**UNITED STATES ENVIRONMENTAL PROTECTION AGENCY
REGION 5**

SUBJECT: Response to National Remedy Review Board Recommendations on the
Continental Steel Superfund Site, Kokomo, Indiana

**Continental Steel Superfund Site
Focused RI/FS**

**Response to National Remedy
Review Board Recommendations**

SCHEMATIC LAYOUT FOR
SITE-WIDE GROUNDWATER
ALTERNATIVE MM-3

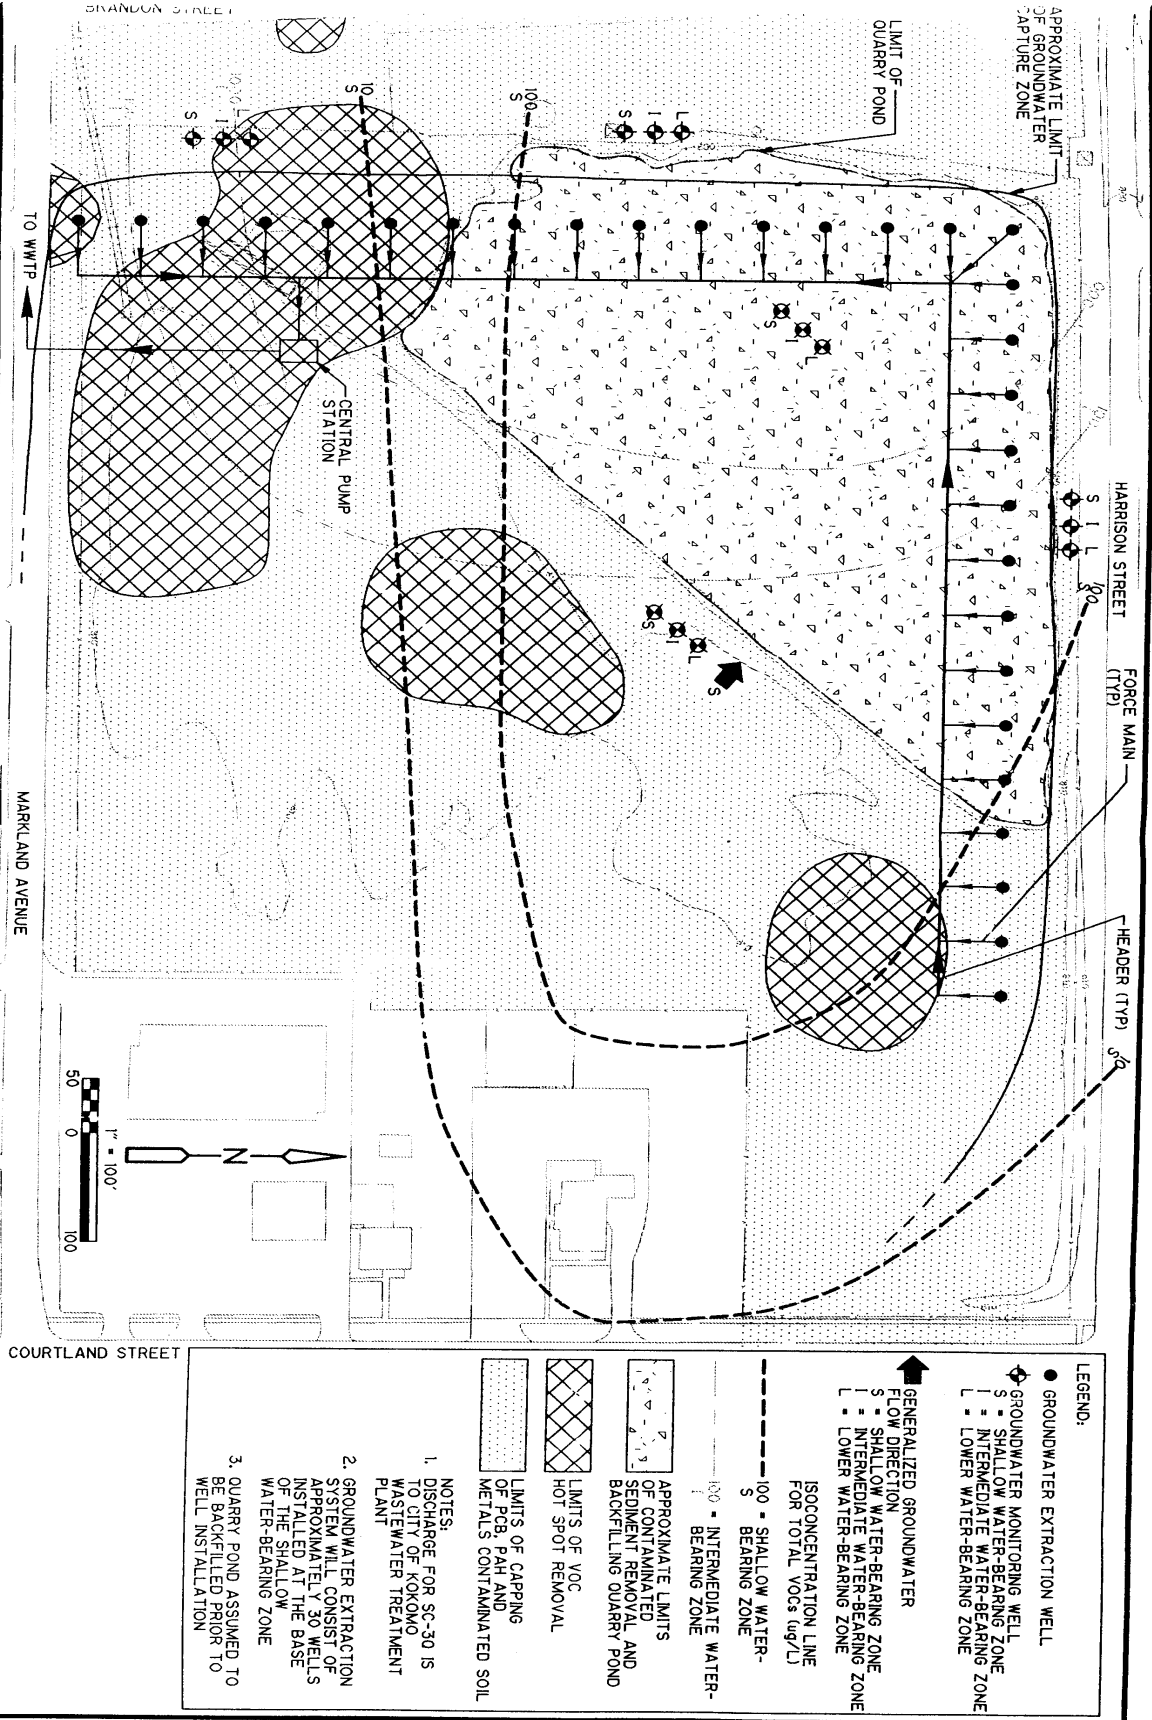
The State should evaluate the appropriateness of locating ground water extraction in the immediate vicinity of the [Markland Avenue] quarry in order to maximize control over potential plume migration westward toward the creek. For the area between the recovery system and the creek the State should investigate monitored natural attenuation as an alternative to the proposed recovery system to restore the shallow groundwater.

Site-wide groundwater was defined as the intermediate and lower water-bearing zones throughout the CSSS and the shallow water-bearing zone that was present outside the limit of the source areas. As such, groundwater extraction alternatives in concert with natural attenuation were presented in the FS for the Markland Avenue Quarry as well as for site-wide groundwater.

For the Markland Avenue Quarry, alternative SC-3Q includes a system of extraction wells located along the western and northern perimeter of the quarry to intercept groundwater in the shallow water-bearing zone. This is shown in Figure 1. This line of extraction wells was situated immediately downgradient of the source area and can be considered in close proximity to the source area. In addition to the interception component, this system would also generate a capture area that should recover some contaminated groundwater in the shallow water-bearing zone that has already migrated from the source area. By inference, this alternative includes groundwater use restrictions and intrinsic remediation in the downgradient areas that were predicted to be affected by the migration of groundwater contamination that could not be recovered by the selected site-wide alternative. Alternative SC-3Q focused on the containment and collection of groundwater in the

It is noted that the groundwater extraction wells are shown schematically as a line of wells in several areas of site-wide groundwater as shown on Figures 2 and 3. It was suggested by the NRRB that in lieu of the line of shallow groundwater extraction wells shown schematically downgradient from the Markland Avenue Quarry, that a line of wells be installed immediately downgradient of the quarry (much as for the source control alternatives presented in the FS) and natural attenuation be utilized for the groundwater downgradient of the capture zone.

This proposed alternative by the NRRB could be utilized for the quarry. The State, in selecting its preferred alternative, did not believe it, cost-effective to provide shallow groundwater controls for contaminants released from the quarry both at the source and downgradient for site-wide groundwater. The State selected the site-wide control as its preferred alternative based on cost and its desire to minimize the need for groundwater use restrictions outside of the present extent of groundwater contamination. Of primary importance was the desire to not allow groundwater contamination above ARARs to potentially migrate to the northwest toward residential areas heretofore unaffected by groundwater contamination. Therefore, the decision was made to intercept the leading edge of the plume in the vicinity of the quarry. In addition, selection of the site-wide shallow groundwater control alternative in this vicinity results in a cost savings of approximately \$50,000 compared to the quarry source control alternative (SC-3Q).

It is estimated that the downgradient extraction combined with intrinsic remediation of the upgradient shallow groundwater will attain ARARs in approximately 30 years. This estimate is 10 years longer than that expected with extraction at the quarry. However, the State believed the extra remediation time was reasonable, given the cost savings and other considerations discussed above.

Upon further review, the State concurs with the NRRB's recommendation because it should achieve ARARs in shorter timeframe in this vicinity and is more compatible with guidance given for justification of the groundwater TI waiver (i.e., implementation of source controls to the extent practical). The State agrees that shallow groundwater control as described in SC-3Q in lieu of adjacent to the creek as described in MM-5 is desirable, even though it will add approximately \$50,000 to the suggested remedy for the site as a whole. This increase in cost of the site-wide remedy is reflected by an increase in the estimated cost of the preferred alternative for Markland Avenue Quarry (2.5Q) of \$390,000 and a decrease in the estimated cost of the preferred alternative for site-wide groundwater (MM-5) of \$340,000.

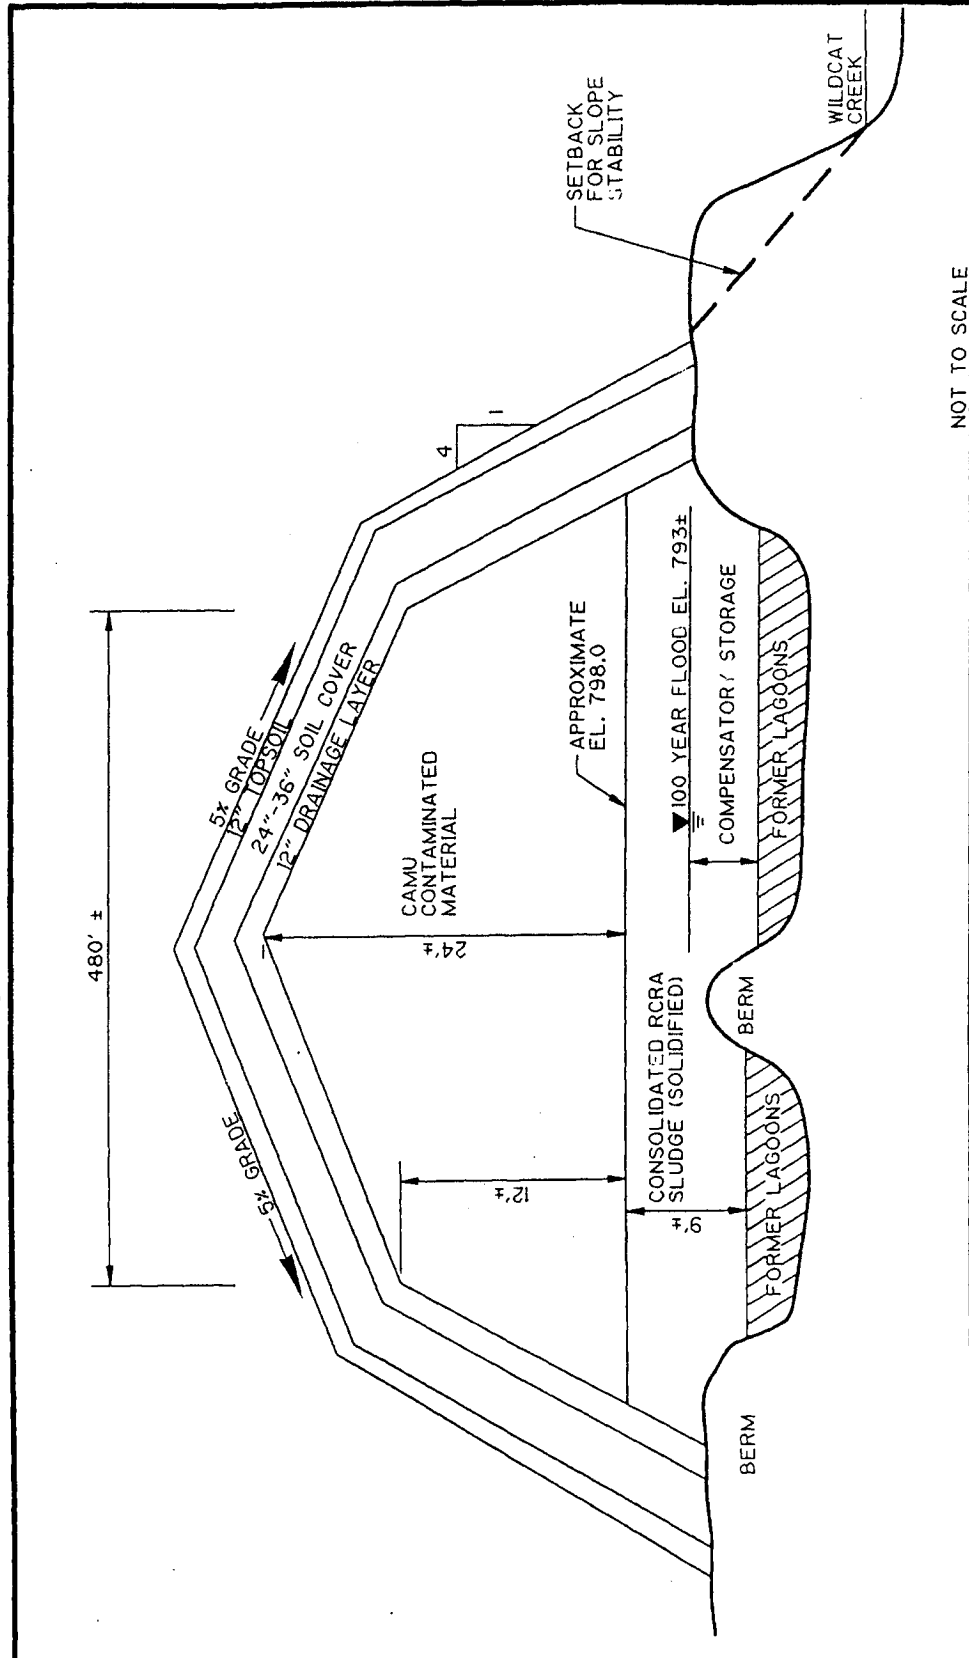
The Board believes that there may be alternative (lower cost) approaches to constructing the proposed "Corrective Action Management Unit" in the lagoon area. For example, adequate dewatering and stabilization of the sludge may be achieved by surcharging the area to achieve load bearing capacity; while adequate cap performance may be achieved using the surcharge soils and proposed impermeable material. The Board recommends that the State evaluate the feasibility of this or similar approaches.

The State agrees that lagoon sludge can be dewatered by surcharging the area to improve load bearing capacity. The State further agrees that if surcharge loading is selected, the material used for preloading can be utilized within the final cap design for the lagoons. The State would be in full agreement with the NRRB if the RCRA closure only of the lagoons were to occur in this area. However, the presence of the CAMU greatly affects the ability to surcharge the lagoon sludge and achieve a load bearing capacity adequate to support up to 40 feet of overlying contaminated fill material in the CAMU. In our opinion, the only way to achieve sufficient load bearing strength is through solidification or integrated construction sequencing that would require phased filling, extended construction durations, and added costs.

The process for surcharging includes the installation of vertical drainage wicks to promote dewatering of the sediment/sludge, placement of a geofabric for material separation and to serve as a working mat, and placement of the surcharge material. This system can result in significant consolidation of the sludge as the water is removed by compression. Up to 50 percent reduction in sludge volume can be achieved, depending on initial water content and percent solids. The most cost-effective use of this design approach is for fairly thick deposits of sludge that will

have a typical capping system on the order of 5 feet in thickness. A key design issue is that the capping system is relatively small in load and uniformly spread out over the lagoon.

For this site, however, there are several site-specific issues that must be considered for design. A schematic cross section of the CAMU is presented as Figure 4. First, the location of the CAMU within a portion of the Lagoon Area results in up to 30 feet of fill material being situated above the lagoon sludge, with the height of fill varying across the site. CDM assessed the potential to situate the CAMU in other source areas. The Markland Avenue quarry area is not appropriate given the area is residential and the CAMU material contains mobile constituents that preclude its use to fill the quarry pond. The slag area is already elevated in topography and is not of sufficient area. The Main Plant is not applicable because of underground utilities and the potential for commercial development. The Lagoon Area was selected because it presents adequate area and is secluded from the public. Therefore, the lagoon closure must consider the CAMU presence or the materials proposed for disposal in the CAMU must be disposed off-site.

Surcharging lagoon sludge as subgrade for placement of an overlying capped landfill is generally not good engineering practice. This is even more important for this site since sludge from other lagoons must essentially be combined under the CAMU to provide compensatory flood storage. Design issues include slope stability, long-term secondary settlements, and overall foundation stability associated with bearing capacity. It is generally required that bearing strengths should be on the order of 25 to 50 psi to provide adequate long-term factors of safety. Surcharging will not be able to achieve this strength improvement, unless 25 to 50 feet of surcharge material is used. As a result, it is not likely that surcharging would be appropriate within the limit of the CAMU.
